# ***TUKWILA SOUTH PROJECT FINAL EIS***

## **Final Environmental Impact Statement**

RE: Tukwila South Project Final Environmental Impact Statement

Figure 2-1

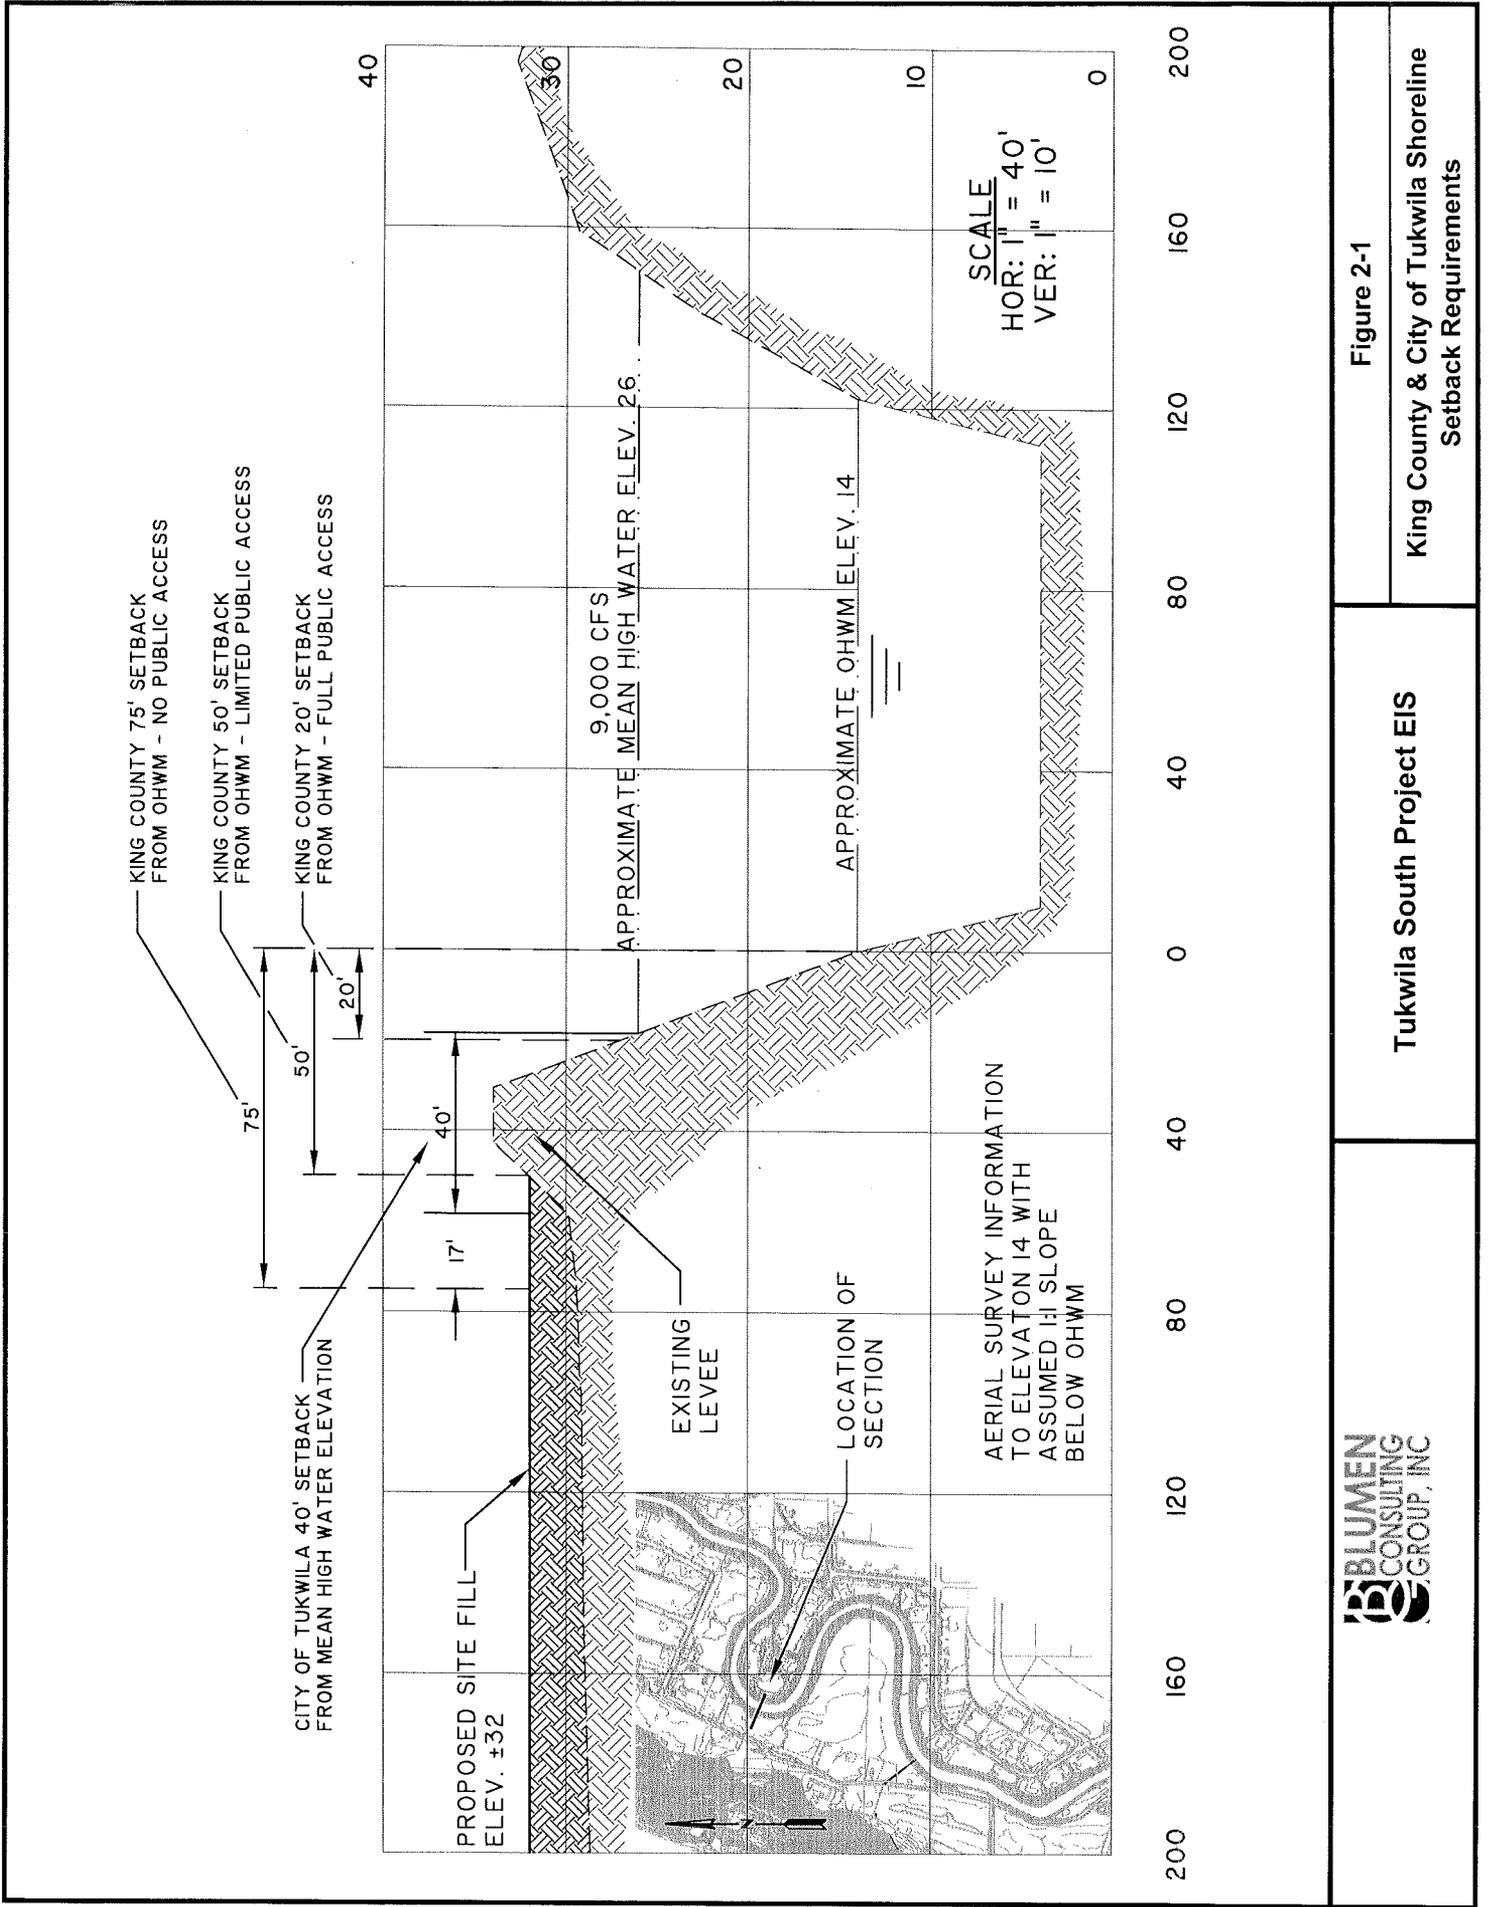
140	2	3.6-2	1		Existing shoreline use. For consistency, add a figure that shows the current SMP designations for the site, including the City of Tukwila SMP designations, such as the "River Environment", "Low Impact Environment", and "High Impact Environment", as well as those currently in effect by King County, and the City of Kent. This figure would be similar to what is shown on Figure 3.6-2 for current zoning/comprehensive plan designations.

The area from the River Environment (40 feet from the mean high water mark) outward 100 feet is designated the “Low Impact Environment”; any development in this area under Alternatives 1 and 2 would be consistent with the low impact regulations provided in the Tukwila SMP. Any proposed development within this zone would be consistent with the allowed uses specified in TMC 18.44.140, which include: structures not to exceed 35 feet in height; parking, loading and storage facilities adequately screened and landscaped; railroad lead and spur trackage, or public or private roads; utilities including towers; and, signs.

All uses allowed in the underlying zoning district are allowed in the High Impact Zone, which is the area designated from 100 feet to 200 feet from the mean high water mark (TMC 18.44.150).

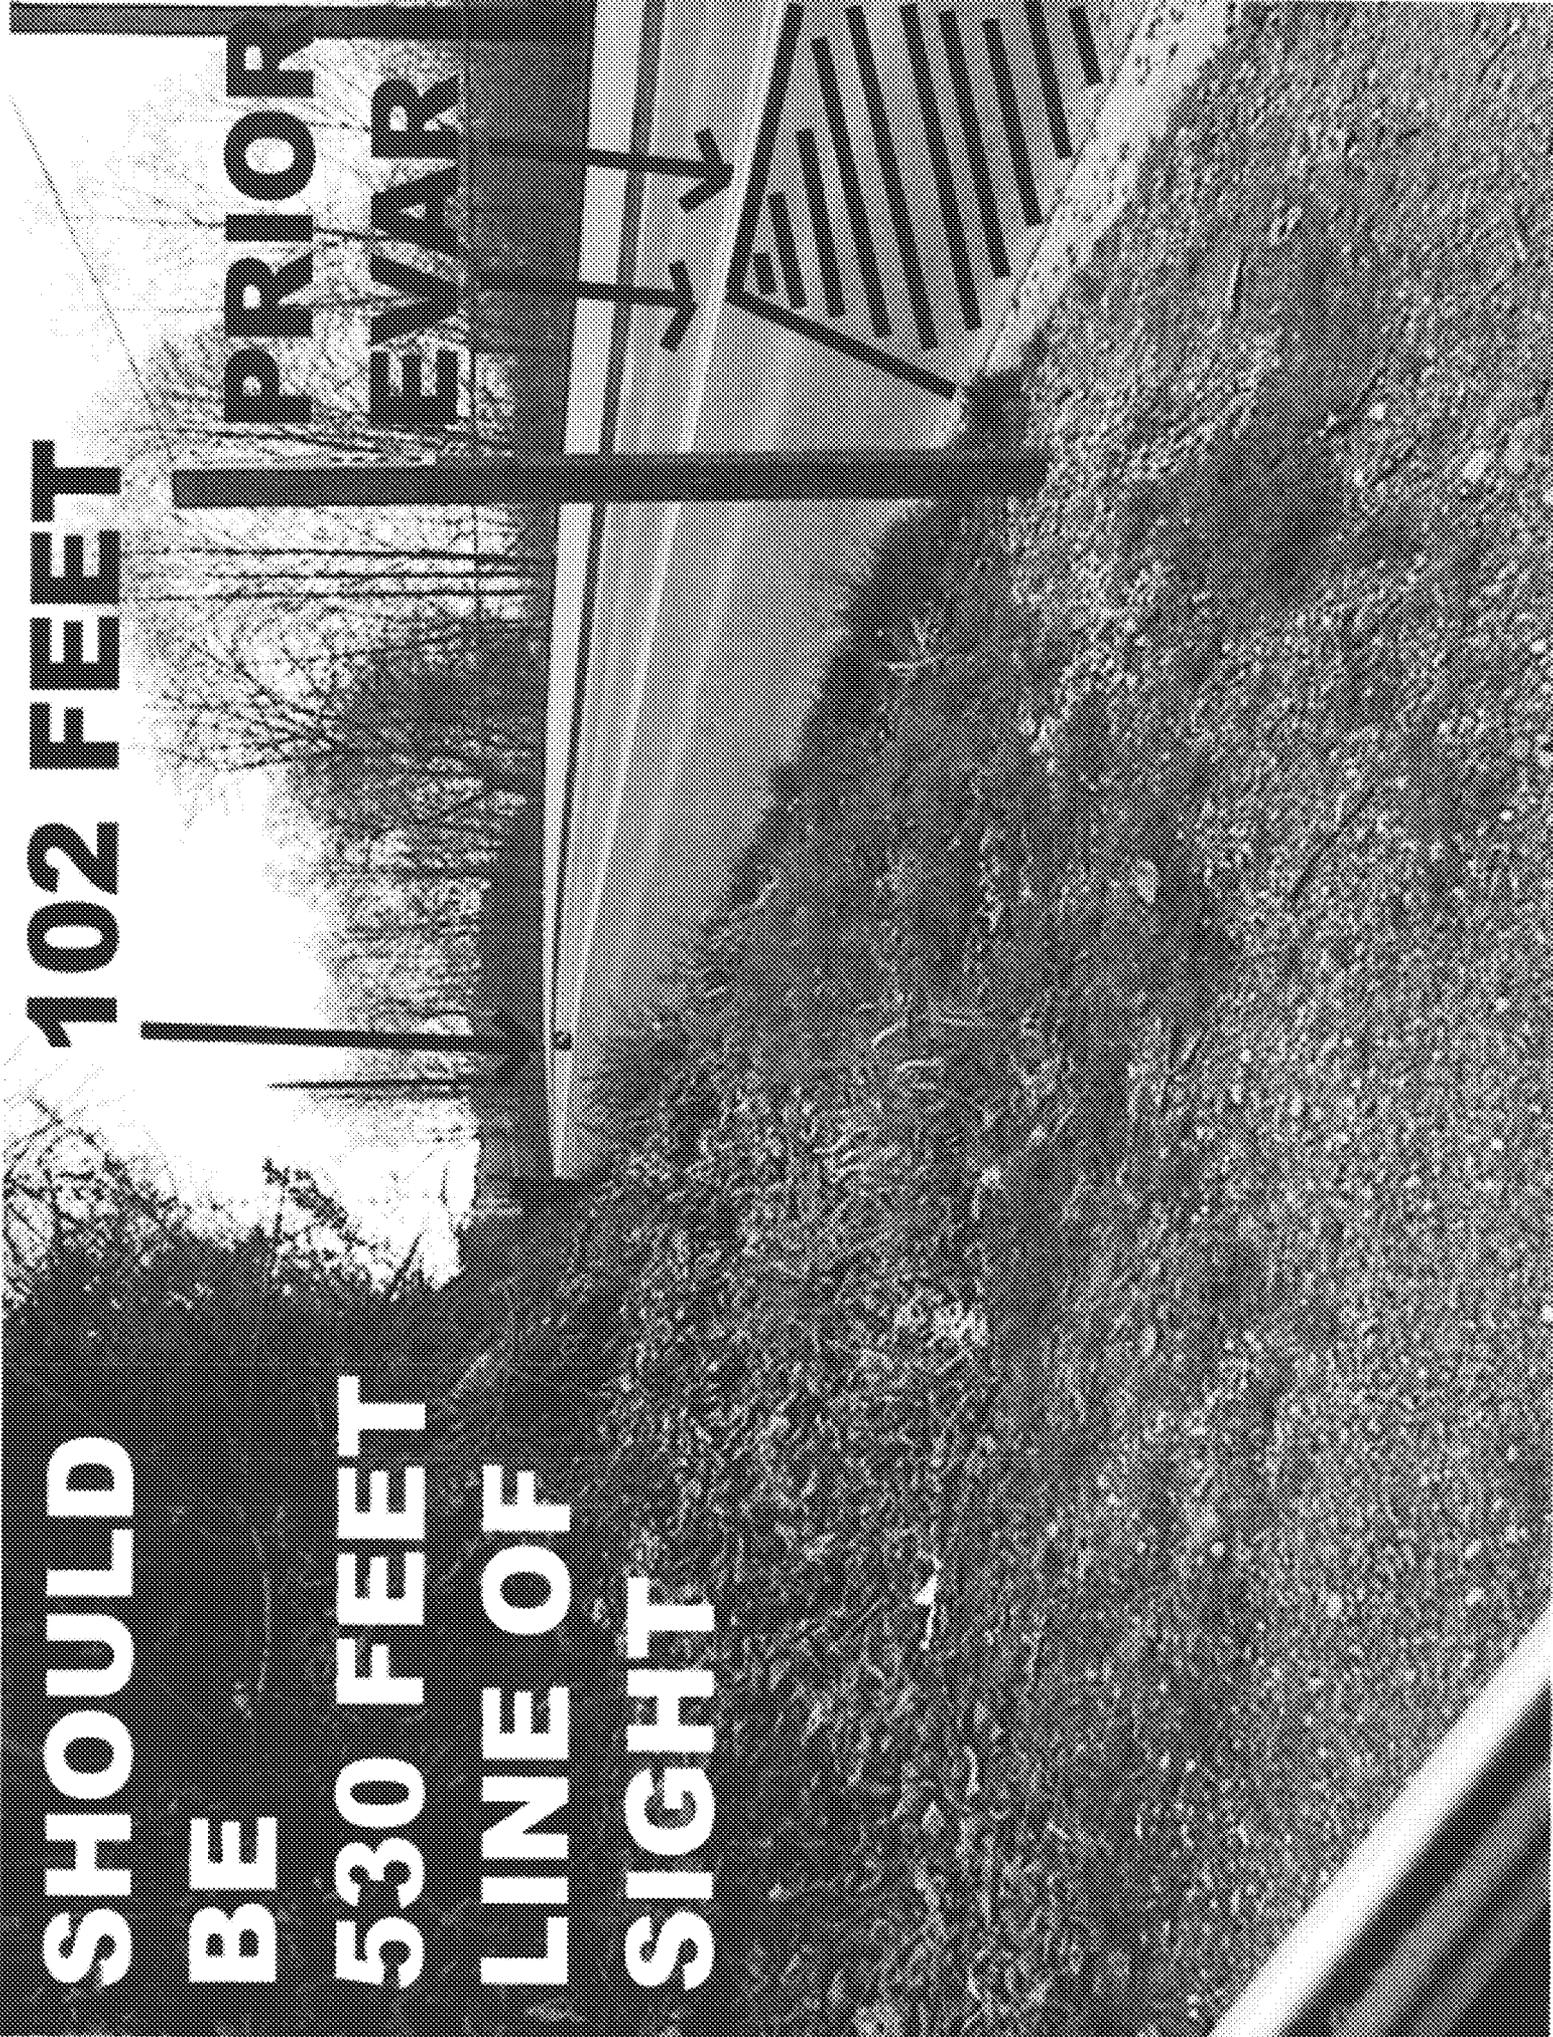
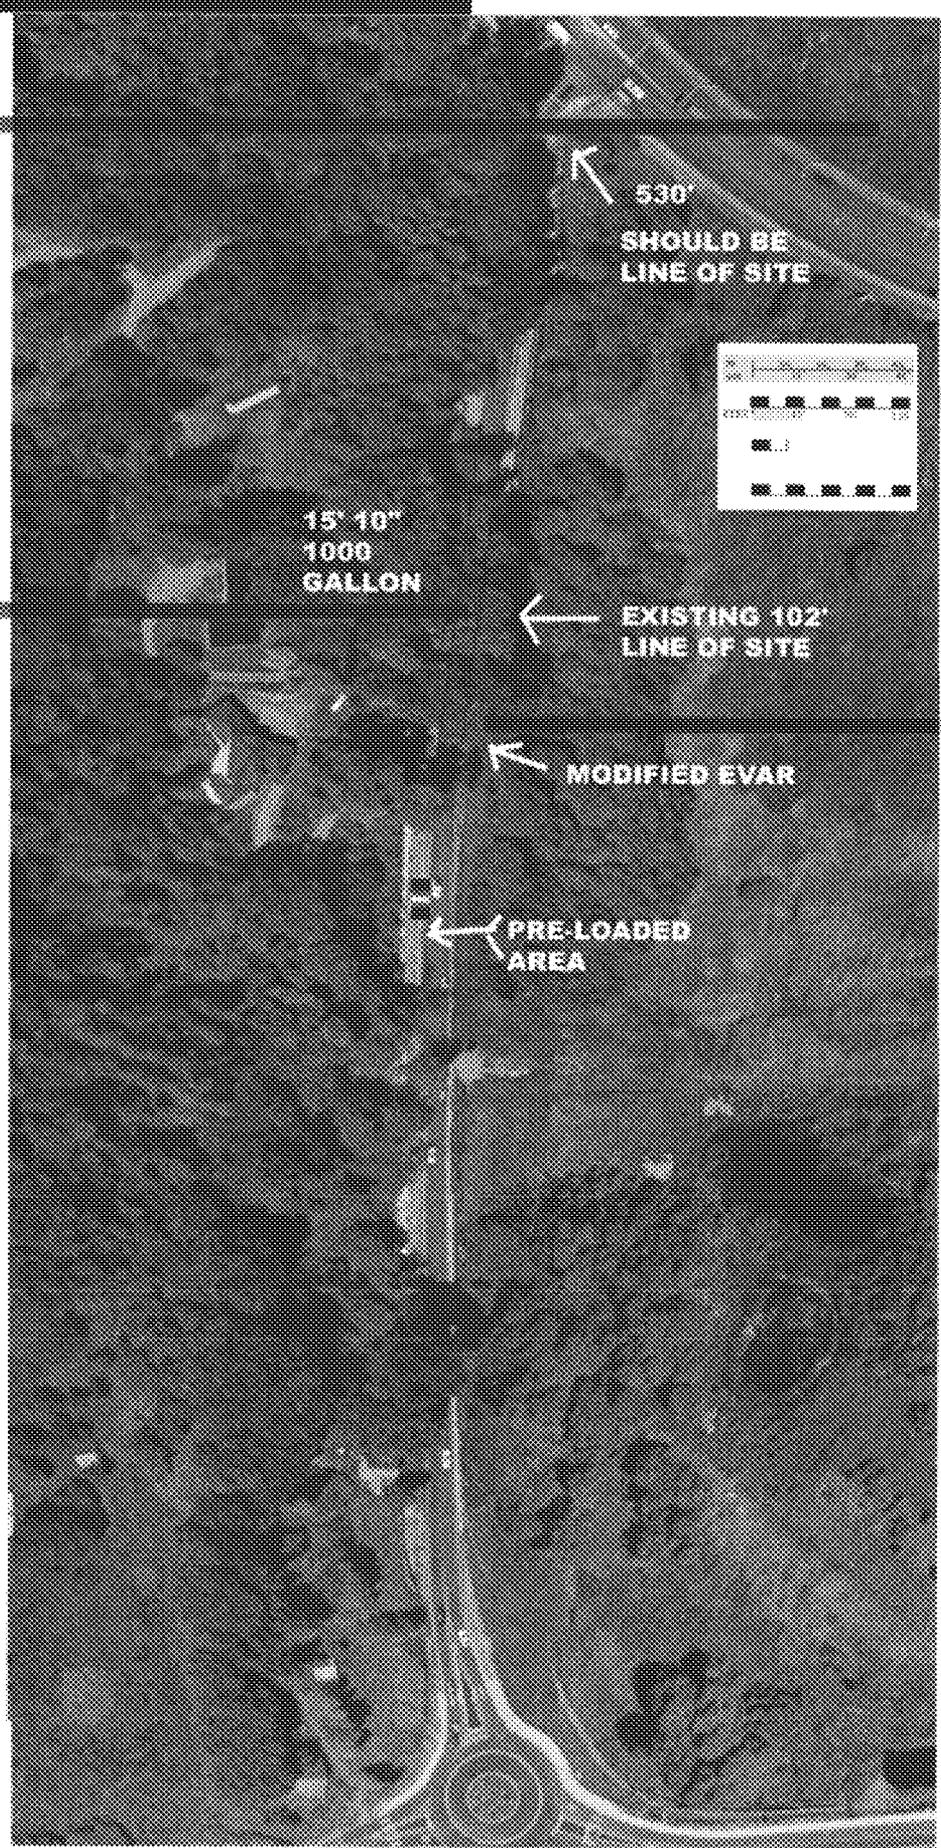
**SHOULD  
BE  
530 FEET  
LINE OF  
SIGHT**

530'  
SHOULD BE  
LINE OF SITE

## **42nd Ave South ROAD HAZARD**

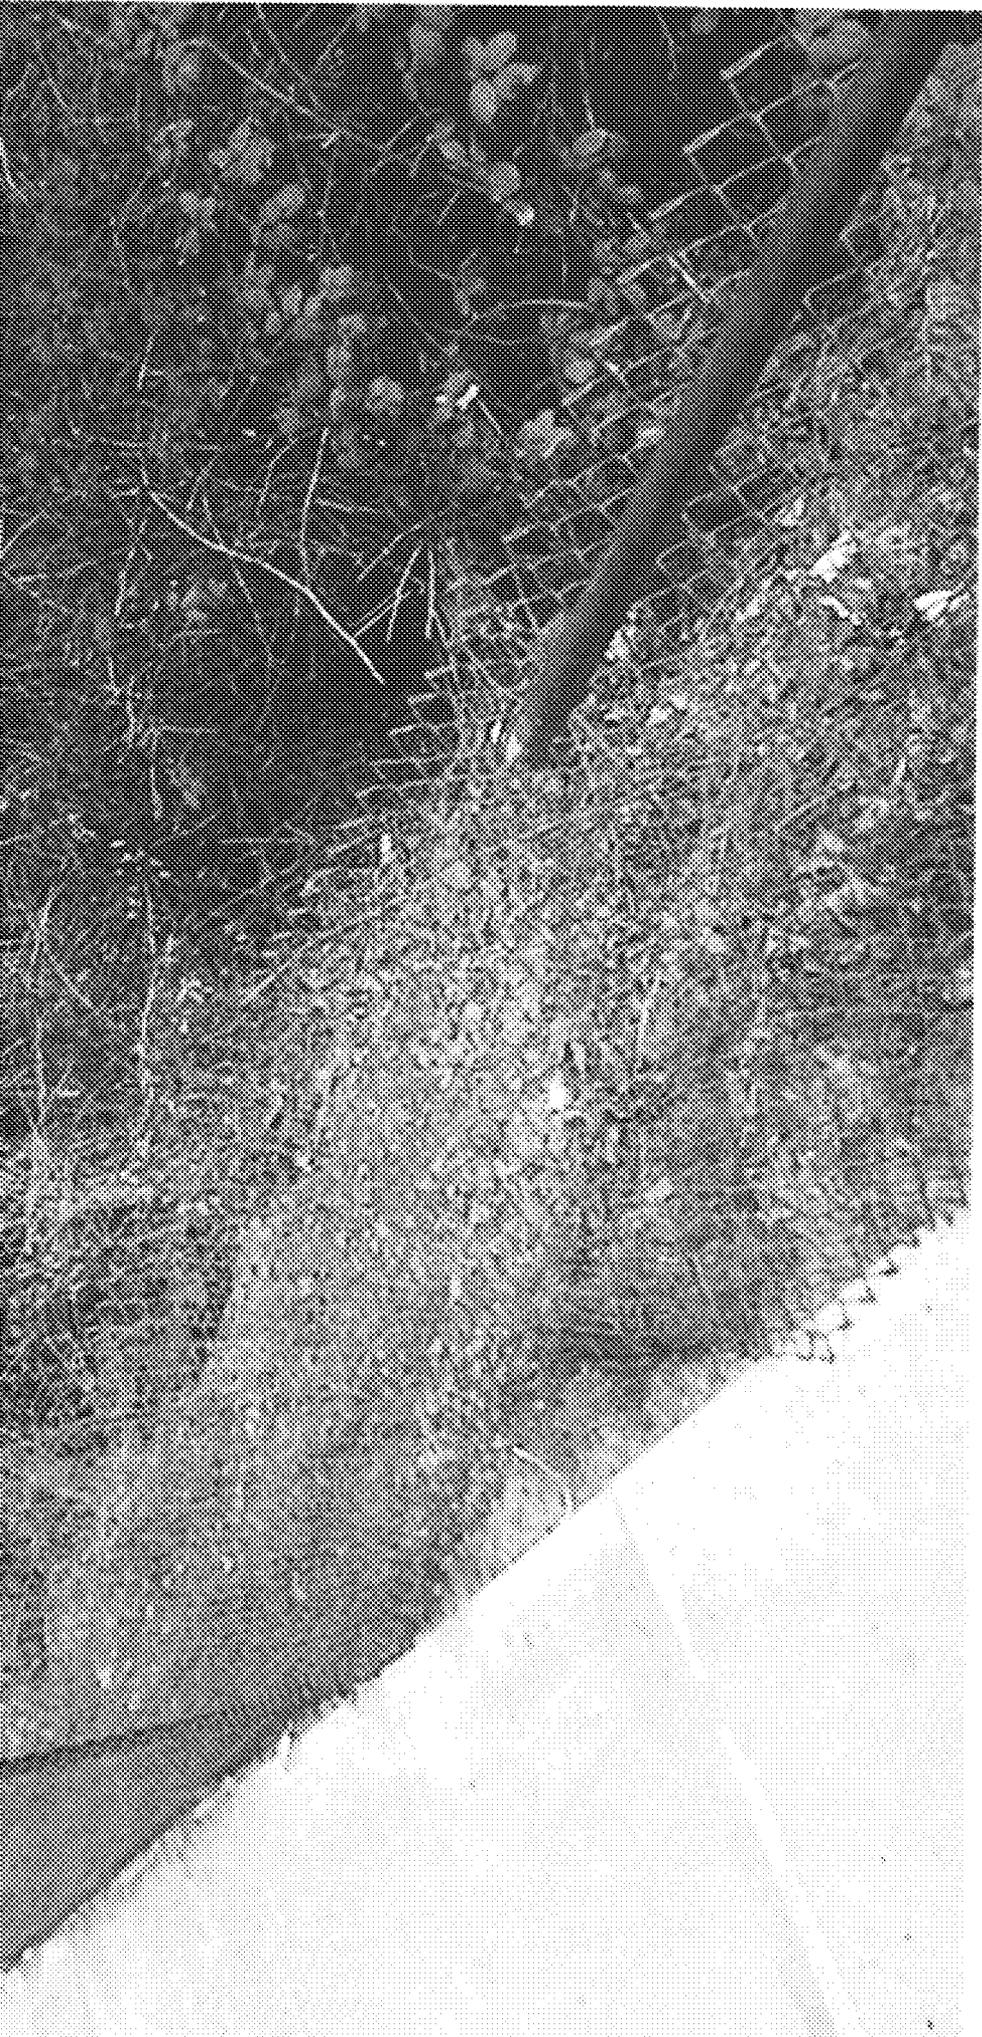
**Both South & North bound Asphalt coming Apart, Water coming up along with Hazardous Line of Site, in violation of City of Kent Codes. Road repaired twice by City of Kent " 3 ACCIDENTS "**

**MOHMED BERKET CRASHED HERE WITH THREE  
OTHER PASSENGERS AFTER HITTING NEW SPRING  
POND IN 42ND AVE ROAD JAN 2005 AFTER  
MODIFIED  
IN 2002  
BY  
DEVELOPER**
